MILITARY SPECIFICATION

RADIO SET AN/URC-80(V)5

This amendment forms a part of Military Specification MIL-R-28823(EC) dated 17 November 1975.

FIGURE 1. Test diagram for leakage current.

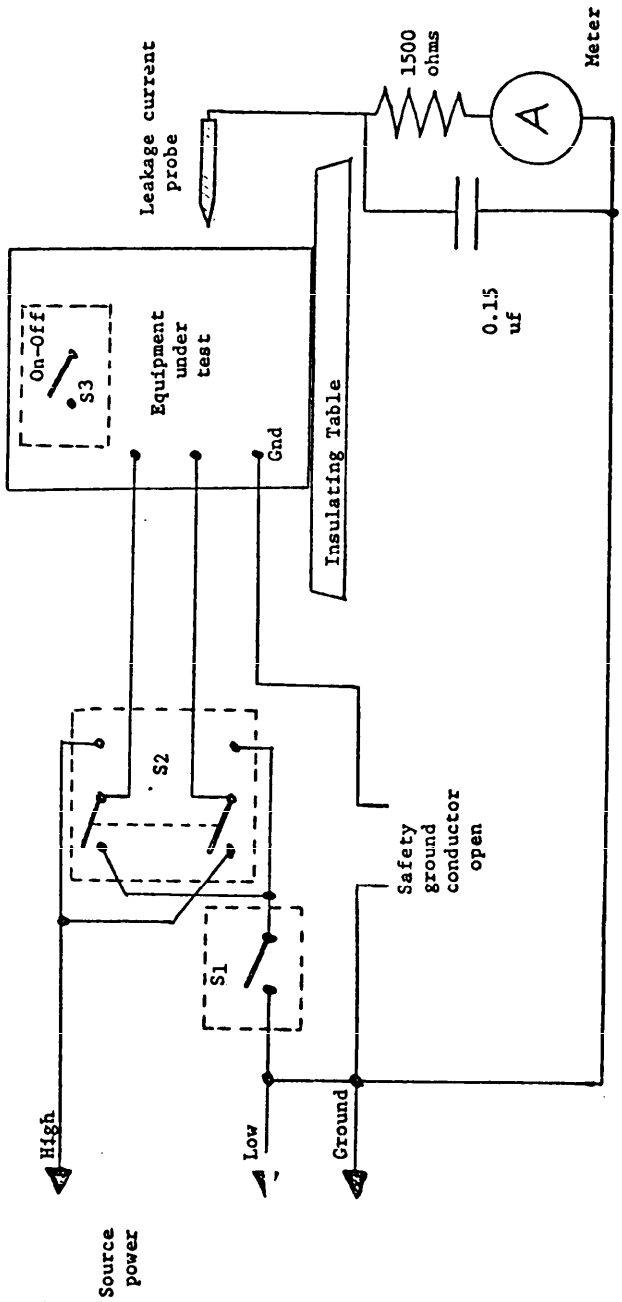
* "4.5.7 Leakage current. Leakage current, as specified in 3.2.1.2, shall be measured in the following manner. The equipment shall be placed on an insulated surface and test connections made as shown in the Test Diagram for Leakage Current, FIGURE 1. All ground connections between the main equipment and other equipments deriving power from the main equipment shall be intact. The ground connection between the main equipment and the safety ground conductor shall be opened. The equipment shall be operating with nominal AC input voltage at 400 Hz. Connect the probe to the equipment enclosure and measure the leakage current for every combination of switch positions available in the test program. All parts not electrically common with the equipment enclosure shall also be tested for leakage current. Equipments having more than one mode of operation, such as transmit and receive, shall be tested in each mode.".

* After 4.5.7, add new FIGURE 1.
